SUBJECT: INDIAN POINT NUCLEAR GENERATING UNIT NO. 2 – ISSUANCE OF
AMENDMENT NO. 290 RE: STORAGE OF FRESH AND SPENT NUCLEAR
FUEL IN THE SPENT FUEL POOL (EPID L-2017-LLA-0408)

Amendment No. 290
License No. DPR-26

SAFETY EVALUATION BY THE OFFICE OF NUCLEAR REACTOR REGULATION

RELATED TO AMENDMENT NO. 290

Figure 3.7.13-1 (page 1 of 2)

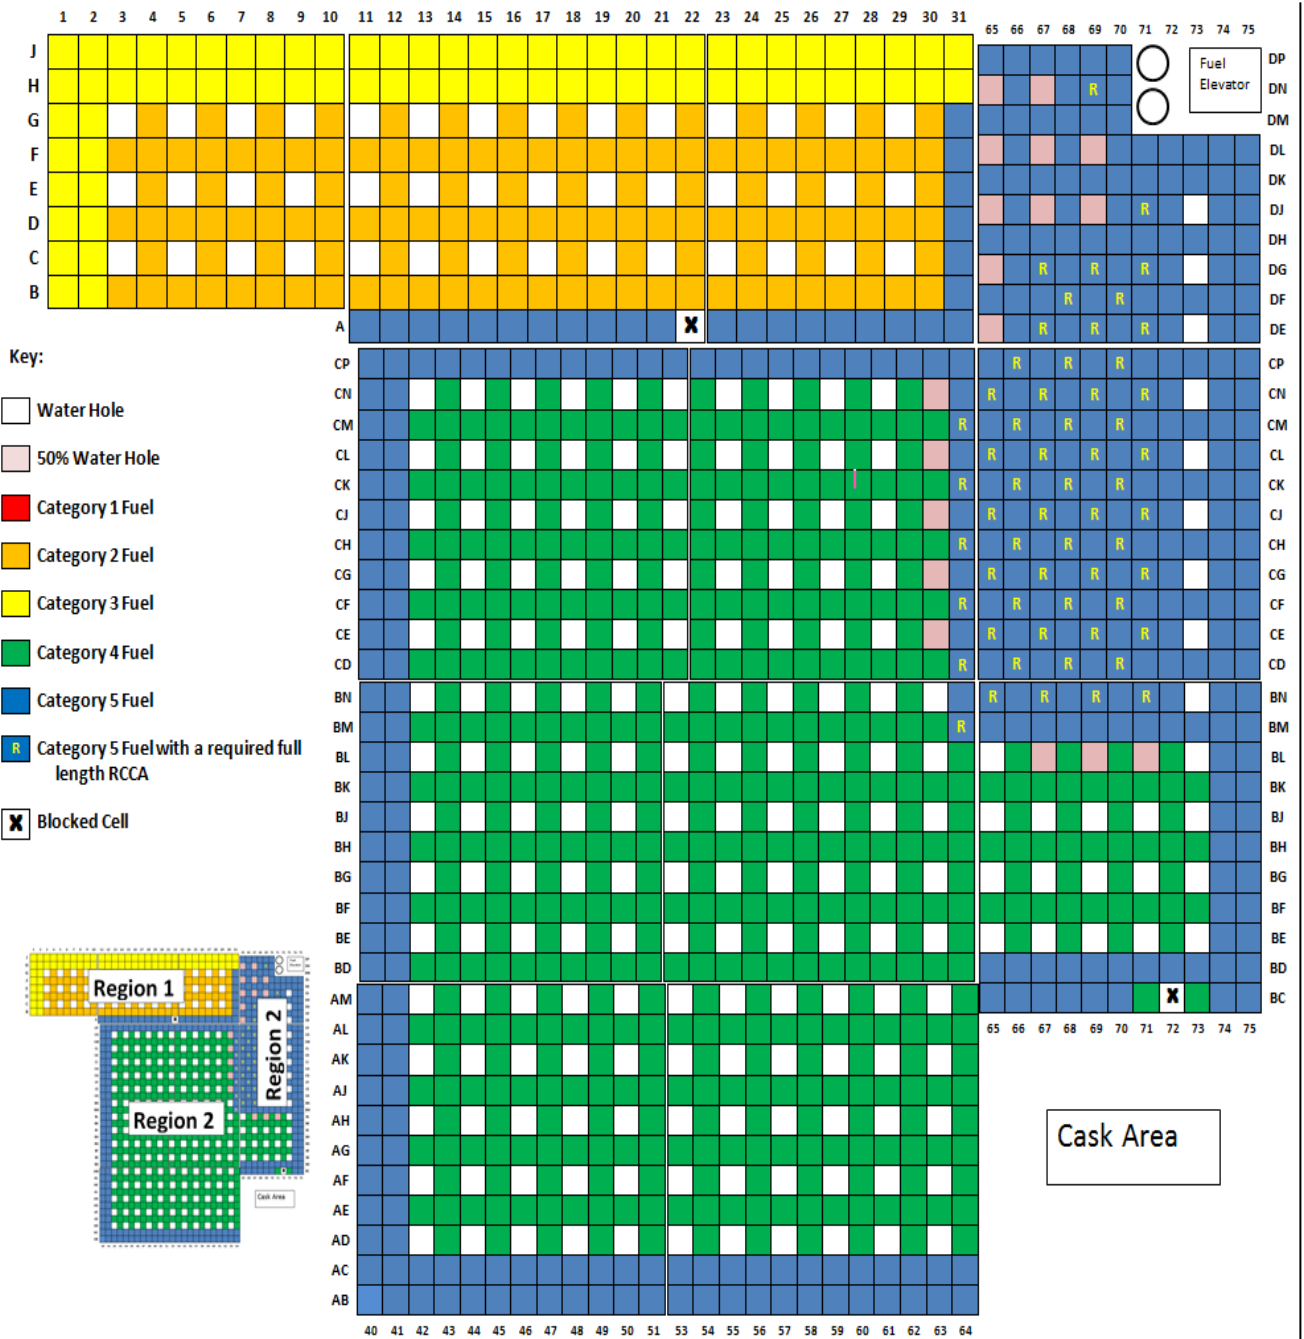
IP2 and IP3 fuel assembly storage locations within the Spent Fuel Pit shall be restricted to locations allowed by Figure 3.7.13-1 and its associated notes.

-----Note-----
Regarding Category 5 fuel assemblies that are required by Figure 3.7.13-1 to contain a full length RCCA - The RCCA must not be placed in or removed while the assembly is in an RCCA required location unless all 8 adjacent cells are empty.

Allowable Spent Fuel Pit Storage Locations for Category 1 through Category 5 Fuel Assemblies in Regions 1 and 2

1. Fuel assembly Categories are ranked in order of relative reactivity, from Category 1 to 5. Category 1 fuel assemblies have the highest reactivity, and Category 5 fuel assemblies have the lowest.

2. Fuel assembly categorization for assembly IDs after X for IP2 and after AA for IP3 must be performed in accordance with Table 3.7.13-1.
3. Fuel assembly Categories for IP2 assembly IDs A through X are located in Table 3.7.13-2.

4. Fuel assembly Categories for IP3 assembly IDs A through AA are located in Table 3.7.13-3.
5. Fuel assemblies of any higher numbered Category can be stored in any cell location that allows for a lower numbered Category. For example, a Category 5 fuel assembly can be stored in Category 1, 2, 3, 4, and 5 cells. Any cell may be empty.

6. Category 1 fuel assemblies that contain a full length RCCA may be stored in any Category 4, 3, 2, or 1 cell.
7. Category 2, 3 or 4 fuel assemblies that contain a full length RCCA may be stored in any Category 5 cell that does not require an inserted RCCA or in any Category 4, 3, 2, or 1 cell.

8. A Water Hole may contain up to 50% of absorber material by volume in the active fuel area. Stainless steel and Inconel meet the definition of absorber material. There is no restriction for non-actinide material outside of the active fuel area.

9. A 50% Water Hole may contain up to 50% of any non-actinide material by volume in the active fuel area. Zirconium meets the definition of non-actinide material. There is no restriction for non-actinide material outside of the active fuel area.

10. A Blocked Cell has the same requirements as a Water Hole.
11. A checkerboard area consists of every other cell being a Water Hole.
12. An area of Category 1 fuel assemblies may be formed in Region 1. The Category 1 area must be formed by replacing the Region 1 arrangement shown in this figure with an area of Category 1 fuel assemblies in accordance with the following criteria (see examples in Figure 3.7.13-2):

- a) Category 1 fuel assemblies must be face adjacent to at least three Water Holes and not face adjacent to another Category 1 assembly.
 - b) Category 2 fuel assemblies must not be face adjacent to more than one Category 1 fuel assembly.

- c) Category 3 and Category 5 locations in Figure 3.7.13-1 may not be moved.
13. A checkerboard area of Category 1 fuel assemblies may be formed in Region 2. All four sides of the checkerboard area must be rows of Water Holes.

14. The edge of Region 2 next to the pool wall or cask loading area can be considered to be a row of Water Holes.
